**SUBJECT:** NuScale Power, LLC Supplemental Response to NRC Request for Additional Information No. 232 (eRAI No. 9113) on the NuScale Design Certification Application

## **Response to Request for Additional Information Docket No. 52-048**

**eRAI No.:** 9113

**NRC Question No.:** 03.06.03-9

Figure 3.6-23: Smooth Bounding Analysis Curve for Main Steam System Nominal Pipe Size 8 Straight Pipe Base Metal

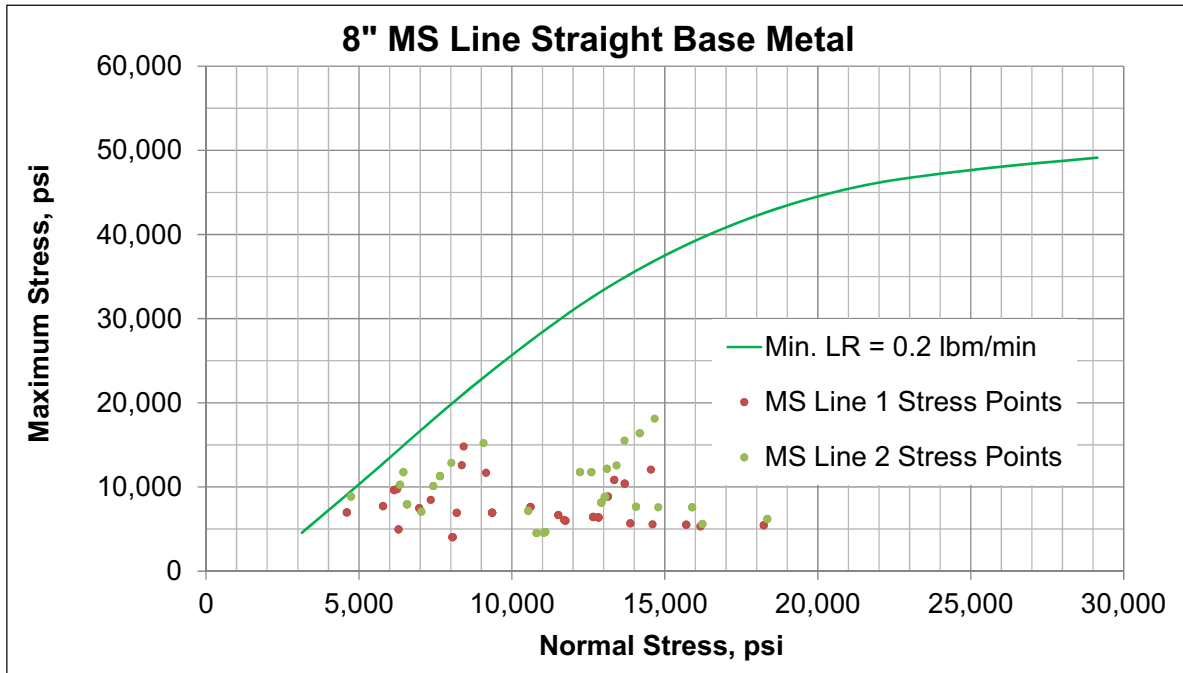
The equations presented in FSAR Section 3.6.3.3 have been used to generate the SBAC Figures referenced in FSAR Section 3.6.3.4 showing normal operating (N) and maximum (N+SSE) stresses for LBB locations. Many of these graphs presented in Figures 3.6-23 through 3.6-32 are unusual in that the maximum (N+SSE) stresses are lower than the normal stresses for some cases. To assist the staff in understanding these graphs, please provide the following;

*If the data has changed from the original FSAR where the piping loads and number of welds have changed, then NuScale will need to provide new BACs for the 36 weld locations so confirmatory analysis can be performed on the new data and assure that the analysis is bounding.*

The FSAR Tier 2, Section 3.6 Figure 3.6-23 through Figure 3.6-28 have been revised as described in the response above and as shown in the markup provided with this response.
